RFB947601-02 ADDENDUM #01

PROJECT: 9476.01 HHS STS New Garage Building – Phase 2

ADDENDUM NO. 1
IDAS HHS STS
NEW GARAGE BUILDING REBID #2
Eldora, Iowa

HGM PROJECT # 106025

project **HHS STS NEW GARAGE BLDG**
3211 Edgington Ave, Eldora, IA 50627
client **IOWA DEPARTMENT OF ADMINISTRATIVE SERVICES**
sheet **ELECTRICAL SCHEDULES AND RISERS**

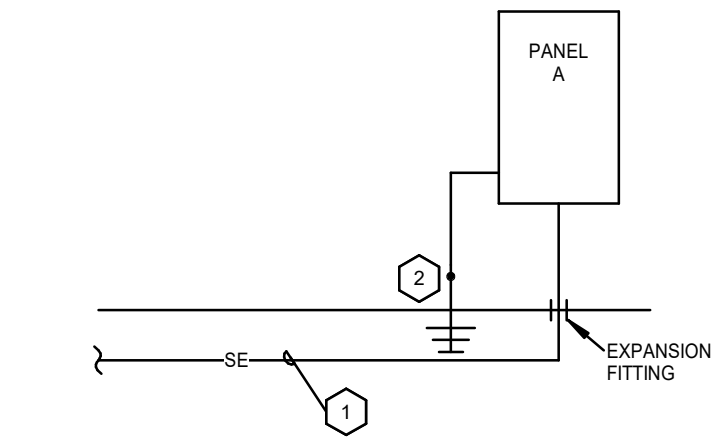
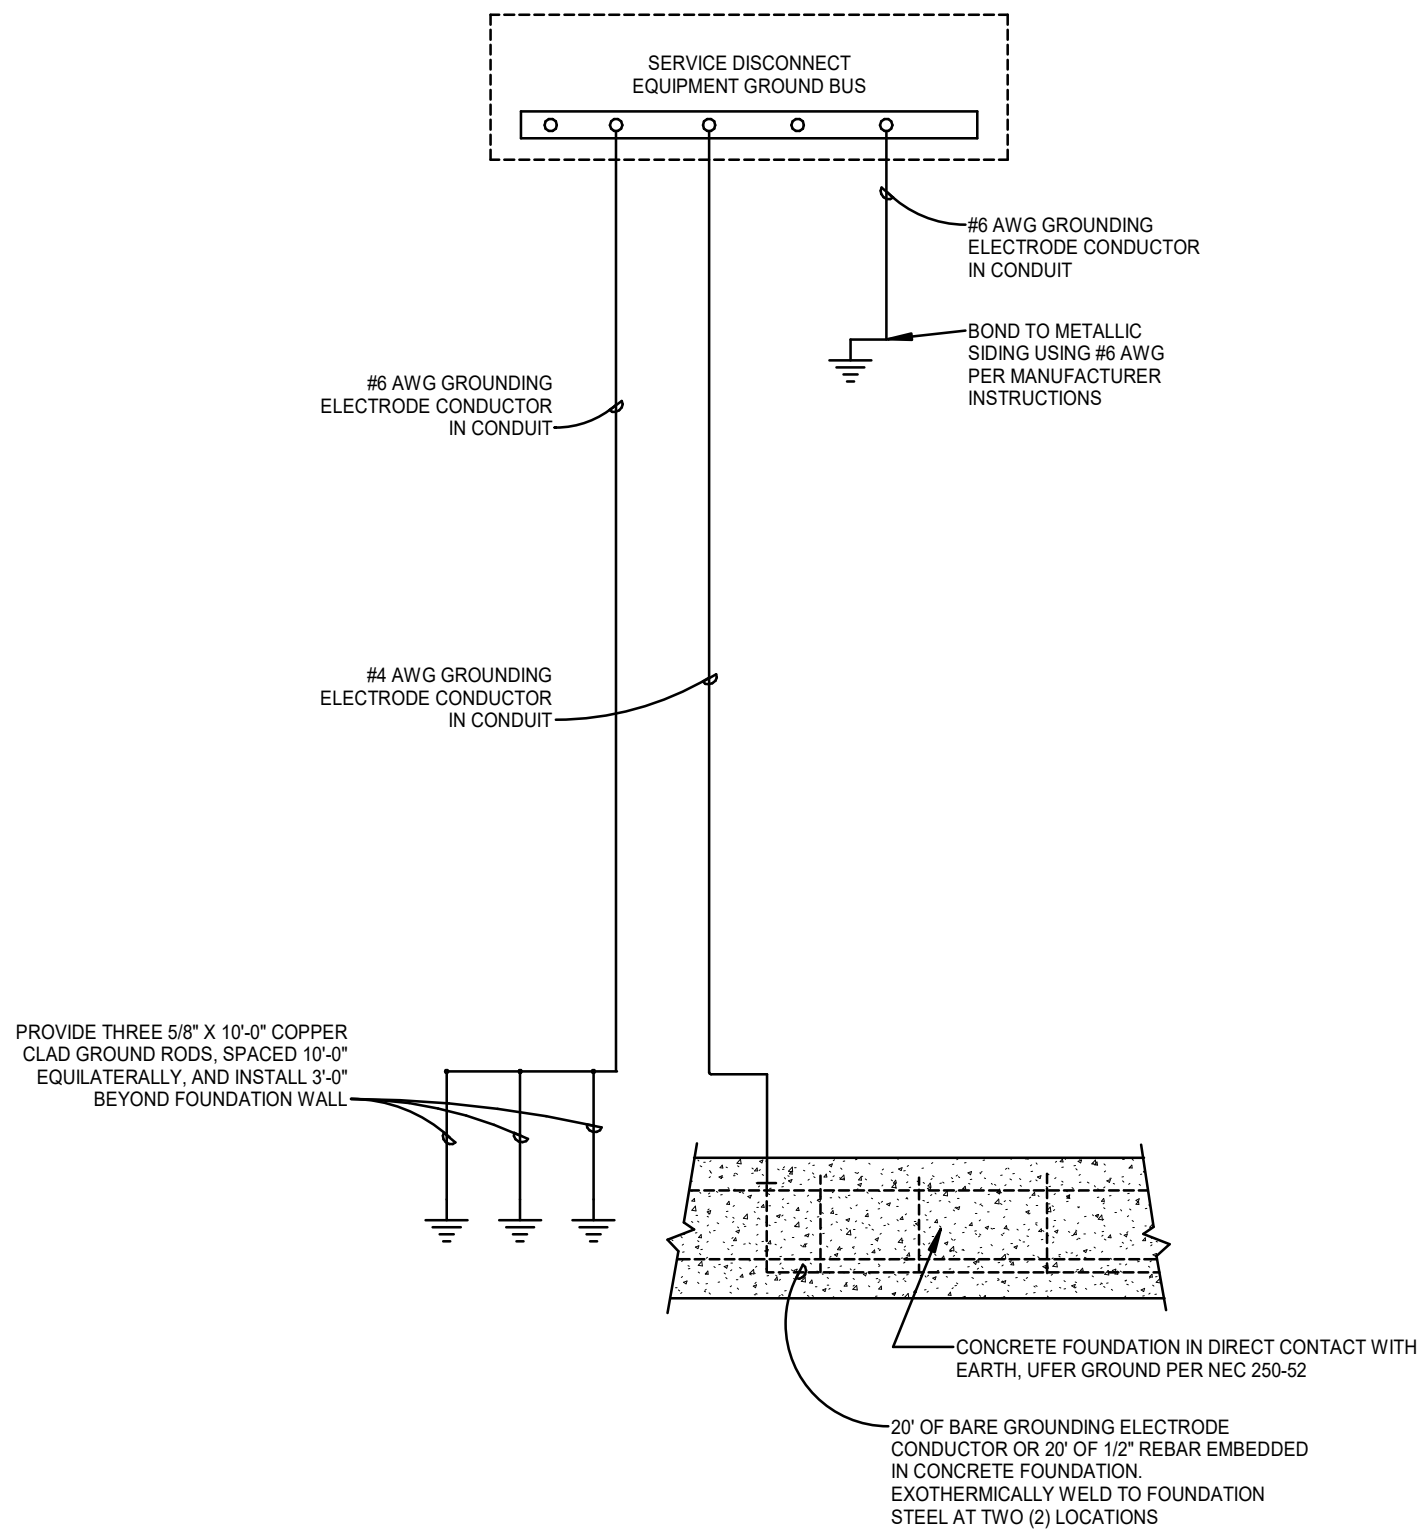
- A: See spec section 31 22 00.
- Q12: E2.1 calls for four #1 aluminum service conductors, but Section 260519 prohibits aluminum. Please confirm the required conductor material and size, conduit size, and transformer termination requirements.

- Q14: MG0.0 requires EF-1 to run 24/7, but E2.1 requires a gas-detection interlock. Please confirm the operating sequence and whether gas detection remains required. If required, identify the devices, controller, wiring, alarms, and furnishing/installing trade.

D. SHEET E2.1 – ELECTRICAL SCHEDULES AND RISERS

- A: Use of aluminum conductors is acceptable where specifically called out. Provide (4) #1 aluminum conductors in 1-1/2" conduit as indicated on E2.1. Contractor shall make connections to the existing pad-mounted transformer and coordinate transformer termination requirements with the Owner's Utility Department in accordance with Section 26 21 00.

- A: No gas detection system is included in this project and should not be included in the note from equipment connect schedule.
- Q15: Please confirm the minimum maintained temperature inside the garage. The scheduled ELM4L standard unit is listed by its manufacturer for 50-104 F. Please confirm suitable emergency/exit lighting and remote-head capacity/configuration for the actual environment.

1. Revised catalog numbers for light fixture Types 3, EM1, and EX1 to change to fixtures with cold weather battery packs.
2. Deleted note about gas detection system for EF-1 in Equipment Connection Schedule.
